## Industry/TSTF Standard Technical Specification Change Traveler

### RPS and ESFAS Test Times and Completion Times (WCAP-14333)

NUREGs Affected:  1430  1431  1432  1433  1434

## I.1 and I.2

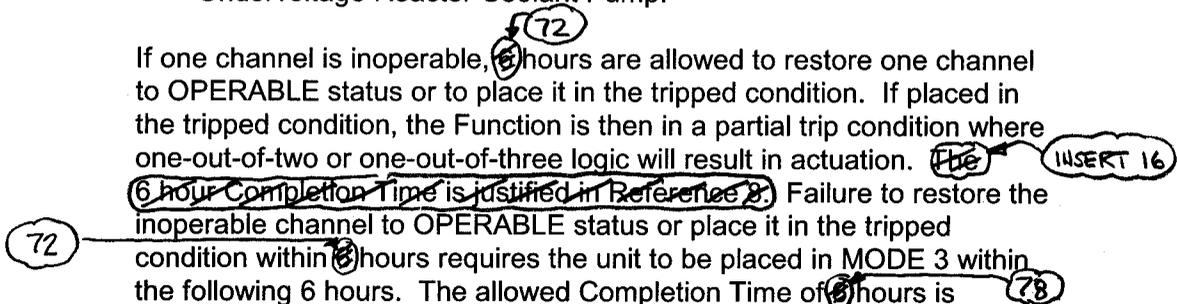
Condition I applies to:

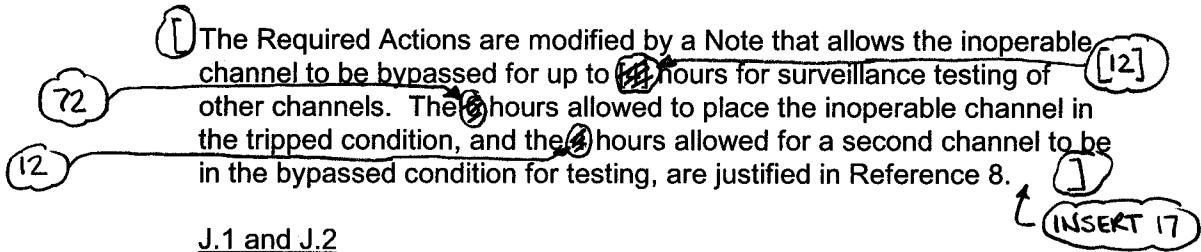
If one channel is inoperable, 6 hours are allowed to restore one channel to OPERABLE status or to place it in the tripped condition. If placed in the tripped condition, the Function is then in a partial trip condition where one-out-of-two or one-out-of-three logic will result in actuation. The

~~6 hour Completion Time is justified in Reference 8.~~ Failure to restore the inoperable channel to OPERABLE status or place it in the tripped condition within 6 hours requires the unit to be placed in MODE 3 within the following 6 hours. The allowed Completion Time of 6 hours is reasonable, based on operating experience, to reach MODE 3 from full power conditions in an orderly manner and without challenging unit systems. In MODE 3, these Functions are no longer required OPERABLE.

The Required Actions are modified by a Note that allows the inoperable channel to be bypassed for up to 12 hours for surveillance testing of other channels. The 6 hours allowed to place the inoperable channel in the tripped condition, and the 6 hours allowed for a second channel to be in the bypassed condition for testing, are justified in Reference 8.
